VILLAGE OF LOMBARD
REQUEST FOR BOARD OF TRUSTEES ACTION
For Inclusion on Board Agenda

TITLE: PC 05-42: 218 and 226 West. St. Charles Road

Appendix A – Revised Plans Prepared by HPD Cambridge

Revised Site Plan

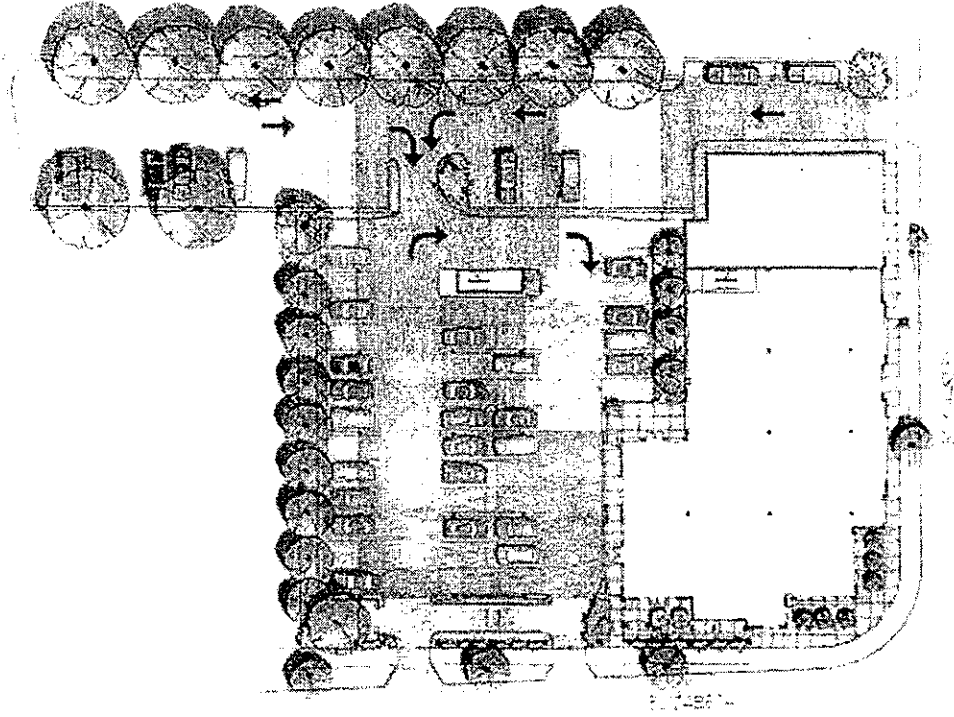
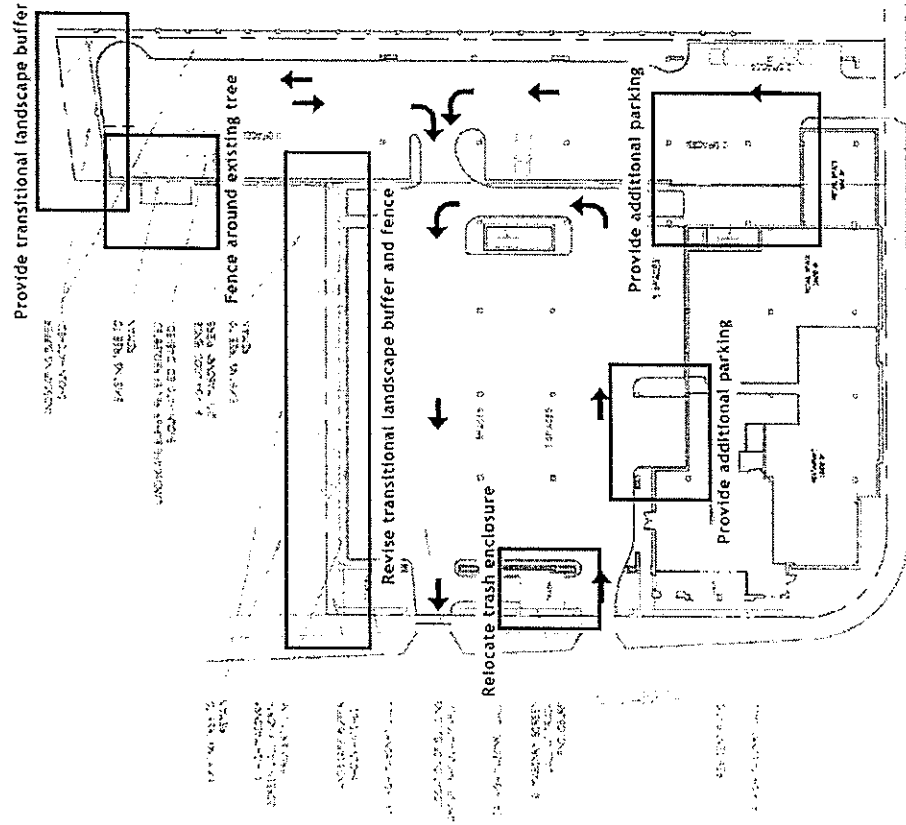
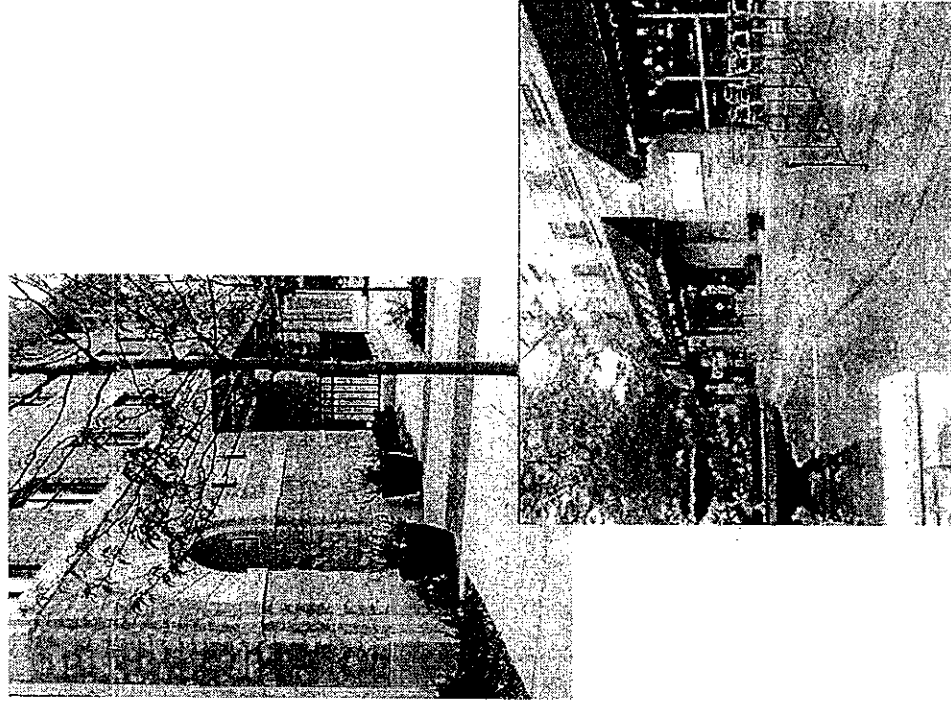
They showed another PowerPoint presentation. They showed a revised site plan depicting where modifications were made. They are pulling the parking area back to the required 10' buffer distance along 26 N. Lincoln. They are proposing a fence line and landscaping treatment. Just below that, there is a tree on the property line. A suggestion was made to run fence around the tree and create some sort of agreement on how to maintain the tree and if they use a system of brick pier and wood fencing between, there is no reason the tree should not survive. But if it doesn't they will take down.

Overview of Changes

Site Lighting

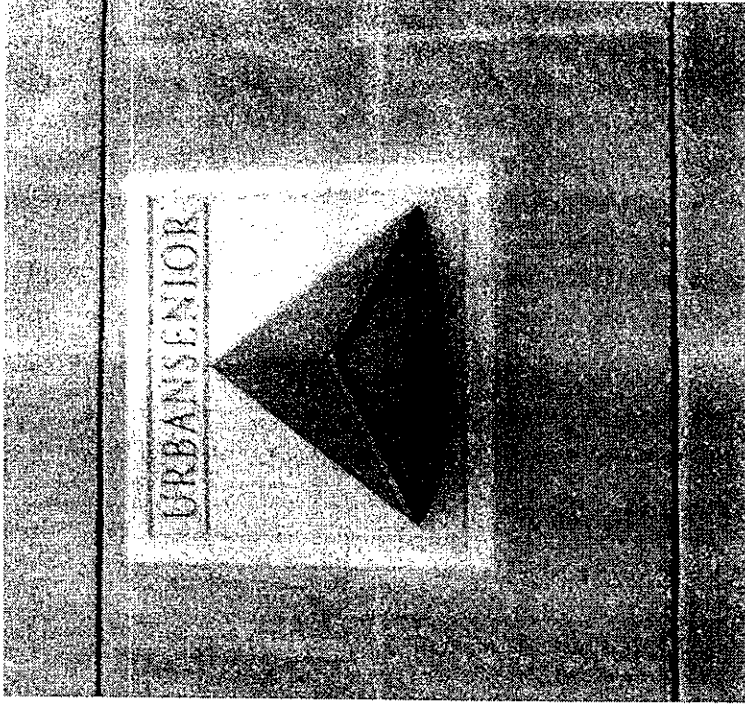
Concern was expressed that lighting would spill over onto adjacent property.

- All lighting for parking under the building will be downlighting (recessed) only and will light only the parking area.
- All lighting for uncovered parking will be bollard type or downlights fixed to masonry piers.
- All fencing and landscaping buffers will be of sufficient height (6' minimum) to prevent headlights from shining onto adjacent property.

Typical downlight on custom masonry piece -- all site lighting in the exposed parking area will be either downlight only or bollard type lighting.

Location of Paving and Parking

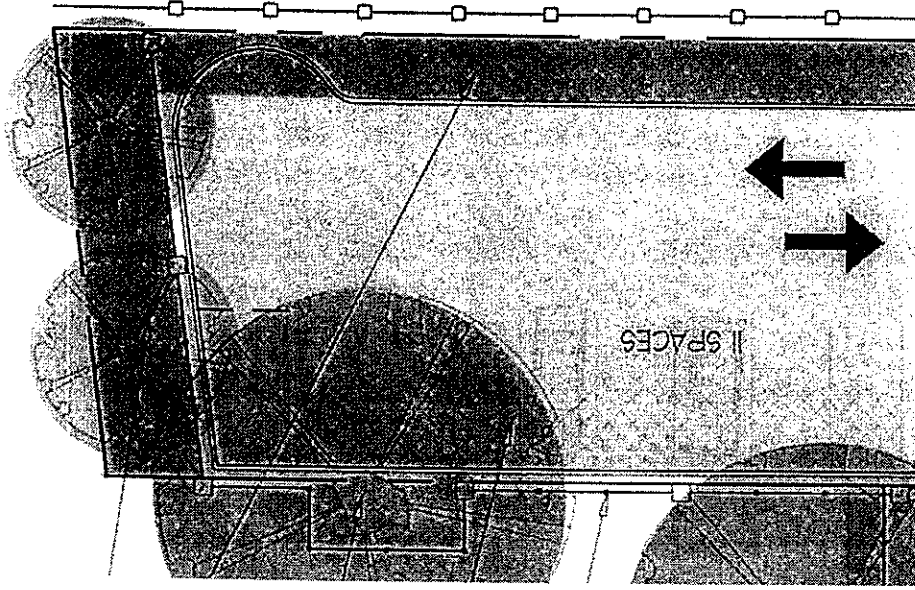
Original proposed site plan placed the north edge of Phase II parking lot within 36" of adjacent property to the north.

- The site plan has been revised to provide for the required 10'-0" landscaping buffer between the proposed PUD and the adjacent R2 parcel at the north edge of the Phase II parcel.

Dumpster

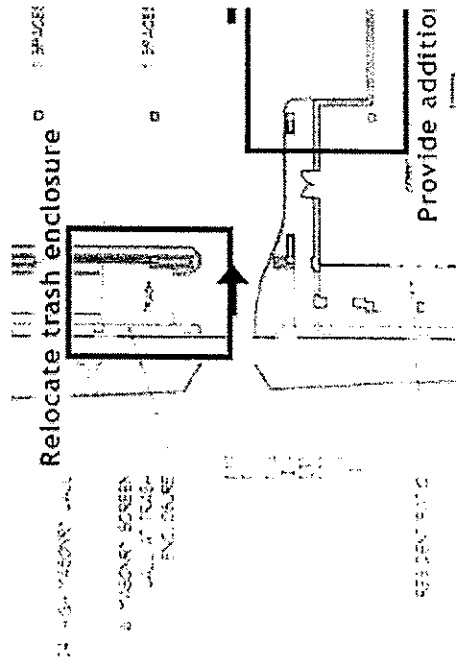
Concern was expressed about the location of the dumpster.

- Dumpster was relocated to be an additional 40 feet away from adjacent property.
- Dumpster will be screened by a masonry wall and trellis roof.

Storm Water Detention and Release

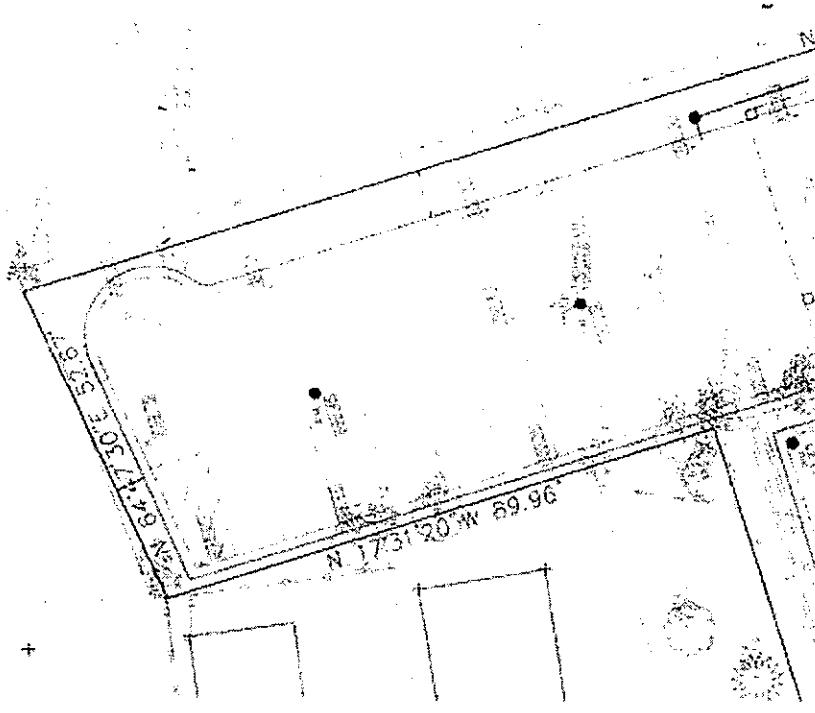
Current grading on the block allows storm water to collect at the low point of the proposed Phase II property.

- The storm water detention system for each phase of the proposed project has been designed to handle all runoff from the project site without impacting adjacent parcels.
- The Phase II storm water detention system for the proposed project has been designed to accept runoff from the Lincoln Terrace property and release it through to the Elizabeth storm sewer.

Parking

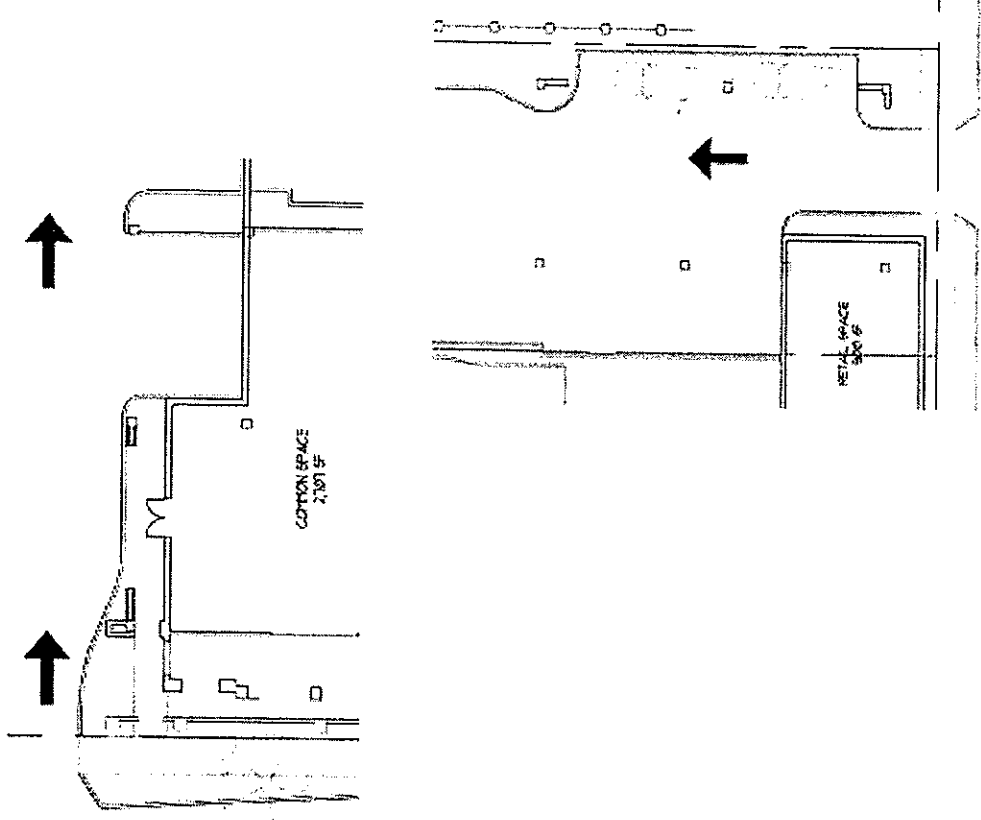
Addressing adequate parking was of particular concern to Commissioners, staff, and citizens.

- Site plan was revised to reflect parking needs as determined by Village staff in conjunction with the Developer.
- Phase II retail space was reduced to minimize parking demand and provide additional parking spaces.
- Total parking needs under the Village Zoning Code are met for Phase I development. Phase II development provides for a .5 per unit parking ratio for residential component

Landscape Buffer at Adjacent Properties

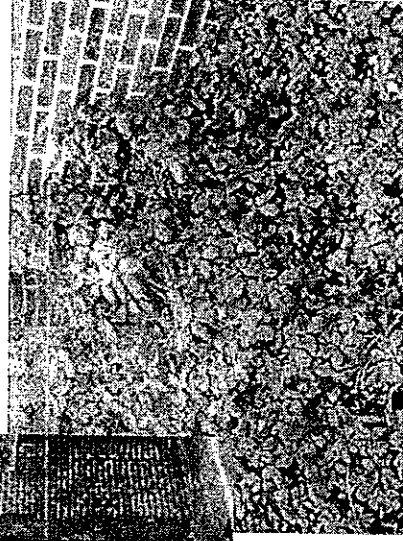
Questions were asked about how the landscaping buffer would be handled at the adjoining properties.

- Phase I north property buffer: masonry wall with planting.
- Phase II west property buffer: masonry piers with wood fence.
- Phase II north property buffer: masonry piers with wood fence and modular retaining wall
- Phase II east property buffer: wood fencing to replace existing
- Prorated contribution to transitional landscape buffer at adjacent properties as negotiated.
